# Access Compliance Report

## Public Rights-of-Way

Intersection ID: N/A	Main Street: BRECKFIELD_CT	Cross Street: KIRKWYND_COMMONS_DR	Location: SE
ADA ID: 471CD35273AB	Ramp Type: PerpDiag	Initial Pass/Fail: Fail	Overall Compliance: No
Codes/Mitigation Info/Possible Solution		Field Measurements/Component Compliance	
Severity Score: 21.25

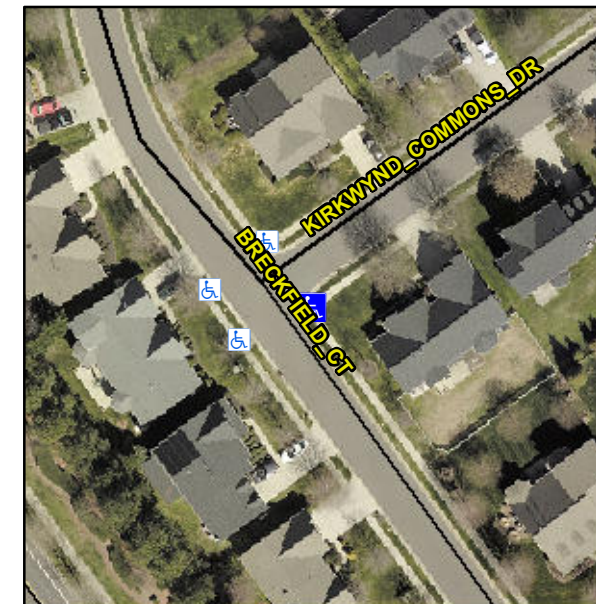
**Remove & Replace Curb Ramp With Two New Directional Ramps or Equivalent.**

**R304.5.1, R304.2.2**

Compliance	Description	Data	Compliance	Description	Data
N/A	Ramp Length (in)	47.0	No	Ramp Slope (%)	8.8
No	Ramp Width (in)	47.0	Yes	Ramp XSlope (%)	1.0
N/A	Flare Type LT	N/A	N/A	Flare Type RT	N/A
N/A	Flare Slope LT (%)	N/A	N/A	Flare Slope RT (%)	N/A
N/A	Flare Traversable LT?	N/A	N/A	Flare Traversable RT?	N/A
N/A	Landing Length (in)	N/A	N/A	DWS Provided?	N/A
N/A	Landing Width (in)	N/A	N/A	DWS Contrast?	N/A
N/A	Landing Slope (%)	N/A	N/A	DWS Length (in)	N/A
N/A	Landing X Slope (%)	N/A	N/A	DWS Full Width?	N/A
N/A	Landing Curb? (Y/N)	N/A	N/A	DWS Offset (in)	N/A
N/A	Shared Landing?	N/A			
N/A	Gutter Ponding?	N/A	N/A	Gutter Slope (%)	N/A
N/A	Gutter Lip Ht (in)	N/A	N/A	Gutter X Slope (%)	N/A
N/A	Painted X Walk1?	No	N/A	Painted X Walk2?	No
	X Walk 1 Direction	To NW		X Walk 2 Direction	To SW
N/A	X Walk 1 Width (in)	N/A	N/A	X Walk 2 Width (in)	N/A
	X Walk 1 Slope (%)	1.9		X Walk 2 Slope (%)	5.2
	X Walk 1 X Slope (%)	1.2		X Walk 2 X Slope (%)	0.6
